### **REMARKS**

**AMENDMENTS TO THE DRAWINGS:**

**FIG. 1**

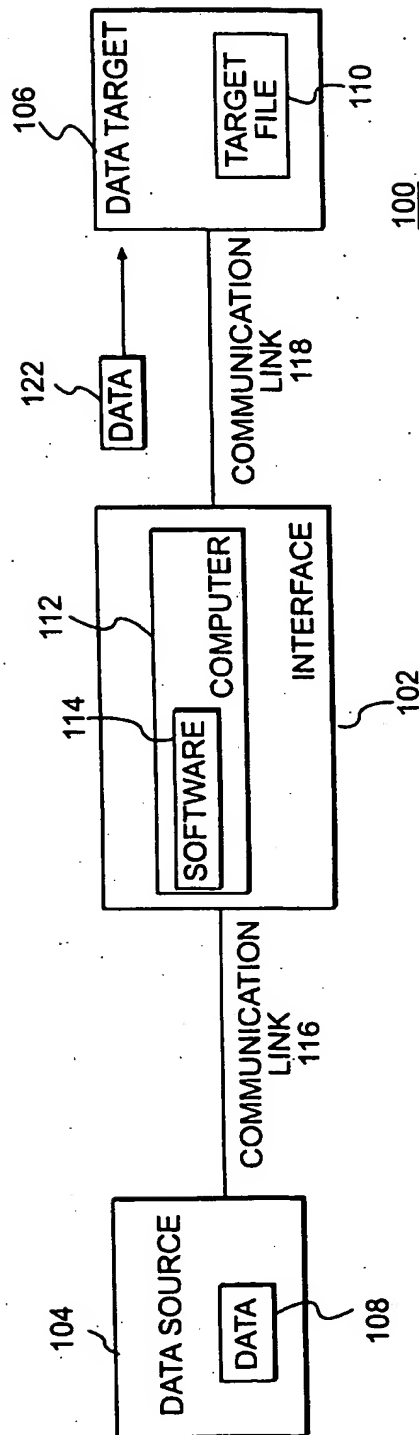
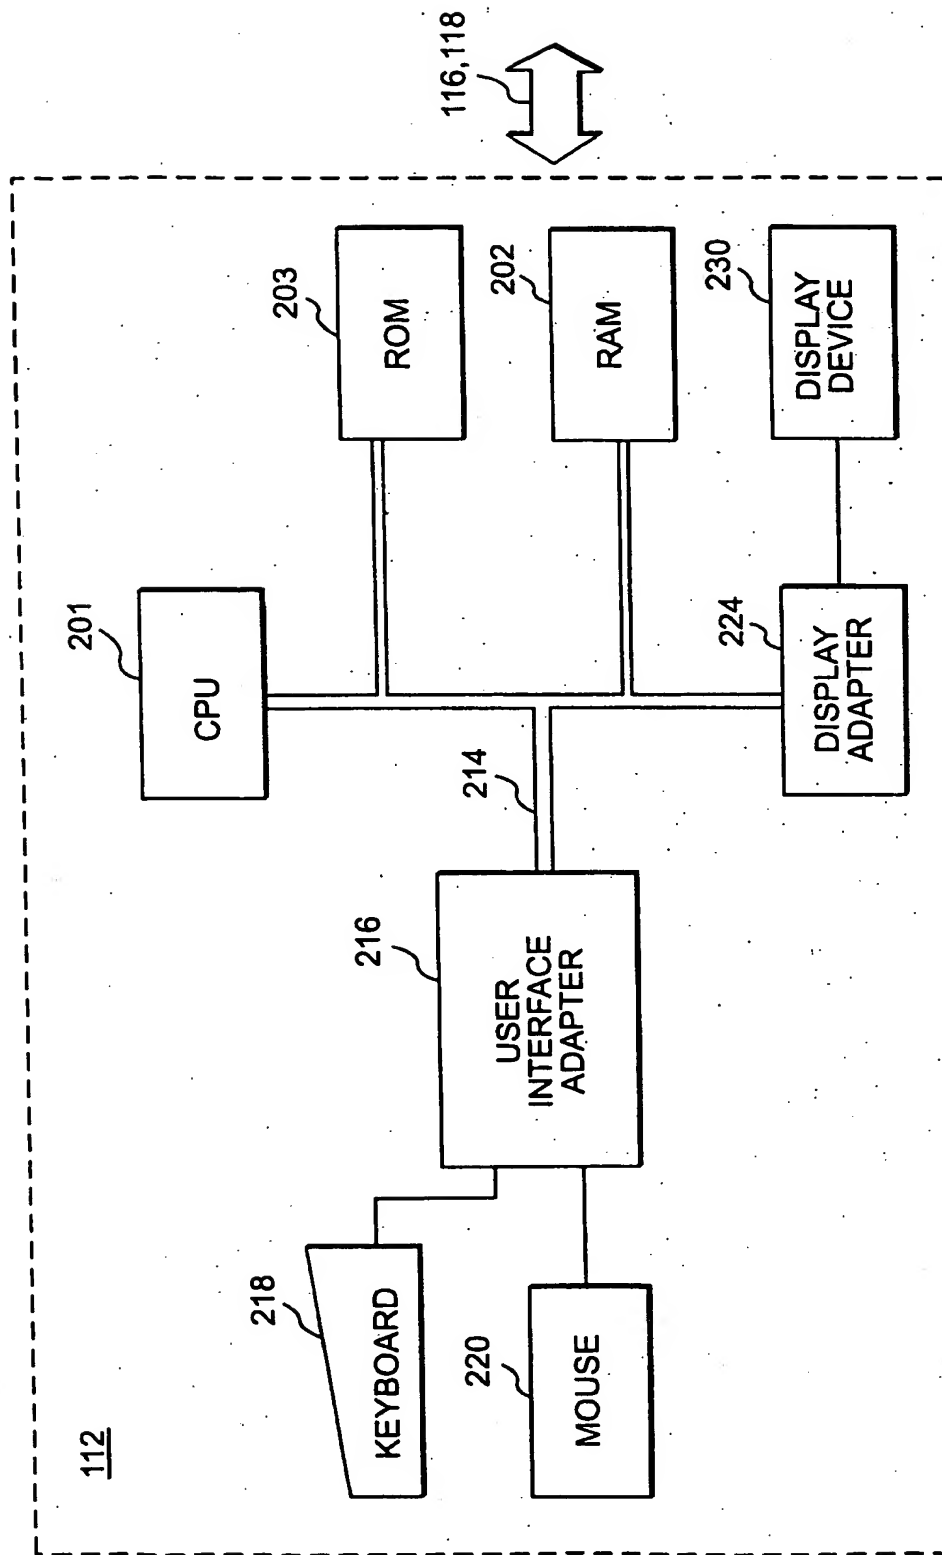
In the Office Action<sup>1</sup> ("OA") mailed January 27, 2006, the Examiner objected to the drawings. Specifically, the Examiner stated that Figs. 1 and 2 "should be designated by a legend such as --Prior Art-- because only that which is old is illustrated" (OA at page 2, lines 7-14). Accordingly, Applicants correct Figs. 1 and 2, as suggested by the Examiner.

The attached sheets of drawings include changes to Figs. 1 and 2 by adding notations as requested by the Examiner.

-- PRIOR ART --

-- PRIOR ART --
